Access Compliance Report

Public Rights-of-Way

Intersection ID: 2847	Main Street: BITTERBUSH_CT	Cross Street: WATERELM_LN	Location:	N
ADA ID: 311B9CBAE28D	Ramp Type: Perp	Initial Pass/Fail: Fail	Overall Compliance: No	Severity Score: 60
Codes/Mitigation Info/Possible Solution		Field Measurements/Component Compliance

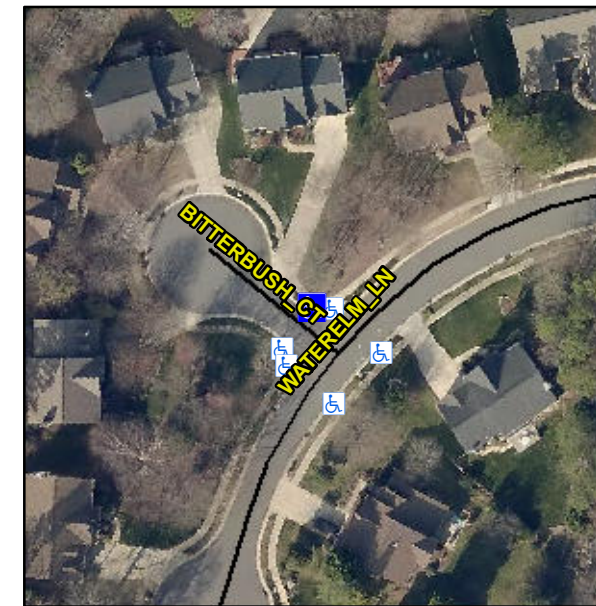
Not Found, R304.5.1, R304.2.2, R304.5.3

Compliance	Description	Data	Compliance	Description	Data
N/A	Ramp Length (in)	47.0	No	Ramp Slope (%)	10.0
No	Ramp Width (in)	26.0	No	Ramp XSlope (%)	6.3
N/A	Flare Type LT	N/A	N/A	Flare Type RT	N/A
N/A	Flare Slope LT (%)	N/A	N/A	Flare Slope RT (%)	N/A
N/A	Flare Traversable LT?	N/A	N/A	Flare Traversable RT?	N/A
N/A	Landing Length (in)	N/A	N/A	DWS Provided?	N/A
N/A	Landing Width (in)	N/A	N/A	DWS Contrast?	N/A
N/A	Landing Slope (%)	N/A	N/A	DWS Length (in)	N/A
N/A	Landing X Slope (%)	N/A	N/A	DWS Full Width?	N/A
N/A	Landing Curb? (Y/N)	N/A	N/A	DWS Offset (in)	N/A
N/A	Shared Landing?	N/A			
N/A	Gutter Ponding?	N/A	N/A	Gutter Slope (%)	N/A
N/A	Gutter Lip Ht (in)	N/A	N/A	Gutter X Slope (%)	N/A
N/A	Painted X Walk1?	No	N/A	Painted X Walk2?	N/A
	X Walk 1 Direction	To SW		X Walk 2 Direction	N/A
N/A	X Walk 1 Width (in)	N/A	N/A	X Walk 2 Width (in)	N/A
	X Walk 1 Slope (%)	5.5		X Walk 2 Slope (%)	N/A
	X Walk 1 X Slope (%)	7.2		X Walk 2 X Slope (%)	N/A

Remove & Replace Entire Ramp.
